Planning & Transportation Committee – 24 February 2021 Further Addendum for Agenda item 4.

Planning application 20/00869/FULEIA: 2-3 FINSBURY AVENUE LONDON EC2M 2PF

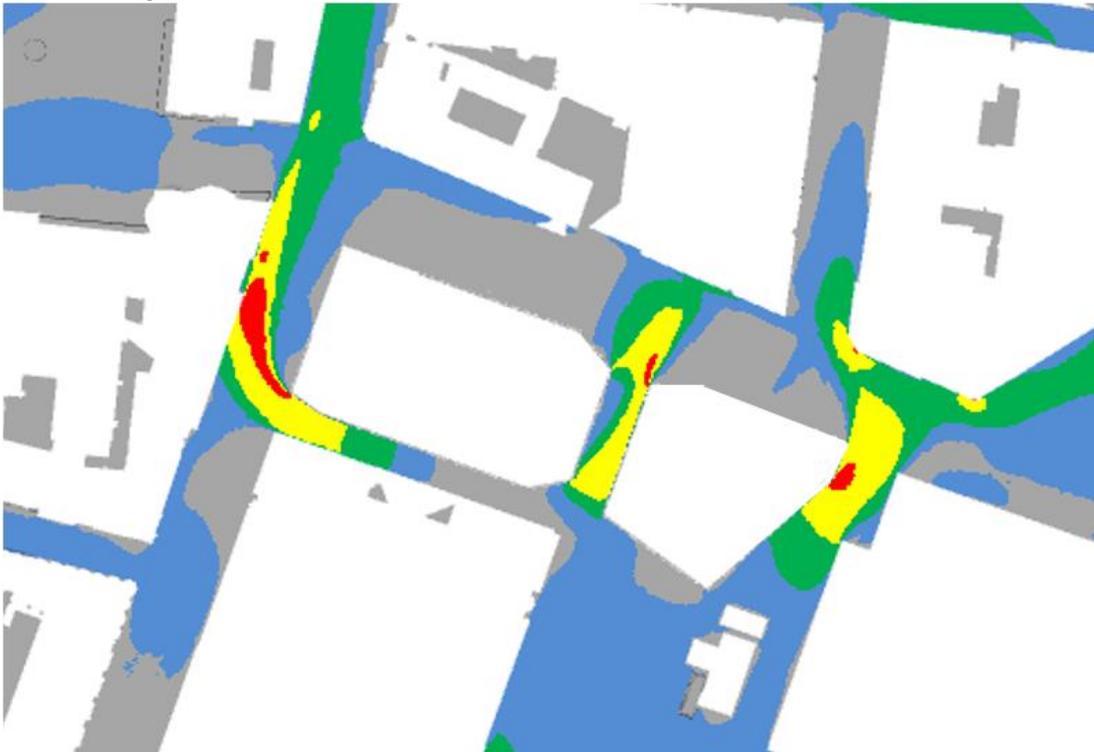
- The gap between the two towers channels air flow in a wind tunnel effect and directs the flow towards the façade of One Crown Place. This effect could cause comfort issues on the façade of One Crown Place. Image 1 in Appendix A highlights this.

Whilst it is recognised that using a Lawson assessment does not reflect the City of London microclimate more stringent guidelines, our assessment indicates a potential region of comfort exceedance at the Sun St end of the central passage underneath the podium of 2-3 Finsbury when expanding the probabilities to reflect the 20° increments. The reverse streamlines from the region of interest indicate the mitigation measures introduced in the applicants CFD and Wind Tunnel reports (in particular the planting in Finsbury Avenue Square and Whitecross Place porous umbrellas) are not in regions through which the stream would pass. This stream is shown in Image 4. This region is of potential concern and should be considered within the post completion wind audit and mitigation introduced if conditions are found to be unsuitable, should this not be considered an area to require further study before commencement of construction.

At 10° increments probabilities this region is close to the limit of walking/uncomfortable categories, and no mitigation measures are either proposed in this area or part of the future planning condition. This region is highlighted in images 2 and 3 of Appendix A. Image 2 represents the 10° increment probabilities and therefore gaps are present in the sector measured. Image 3 expands the probability to fill the gaps between the probabilities tested within the sector.

- The flow visualisation presented in image 1 show the acceleration in wind speeds which is present between the 2-3FA towers, an unoccupied space. The review argues that this acceleration persists onto the OCP façade, which is not supported by the streamlines in Image 1 which change from red to green (a deceleration) as they approach OCP. No plots of wind speeds on OCP terraces have been provided by WR to support the claim that this flow behaviour results in an adverse impact on OCP.
